SITE SUPPLEMENTAL INSTRUCTION

PROJECT: Forestside Estates
Attmar & Palleschi Drive
Brampton, Ontario

PROJECT NO.: 18-017

SITE SI NO. E-7

1.0 Reference Drawing E-3 (Ground Floor - Electrical) Issued

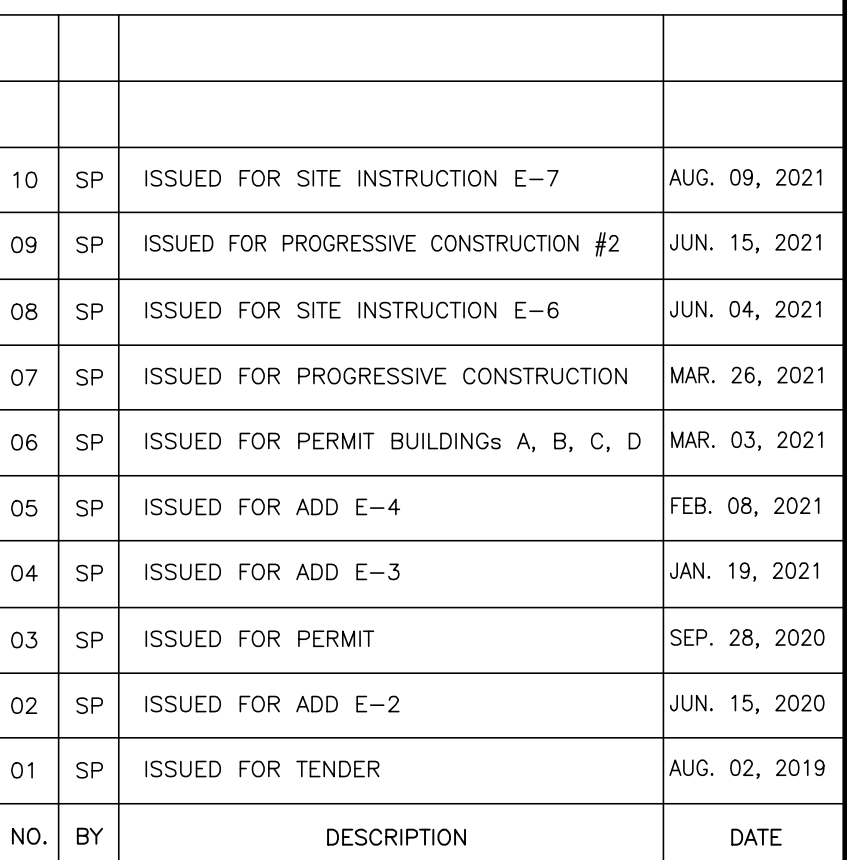
- 1.1 Add: Electric heaters for service room and drive way ceiling as shown.
- 1.2 Revise: Service room electrical layout as shown.
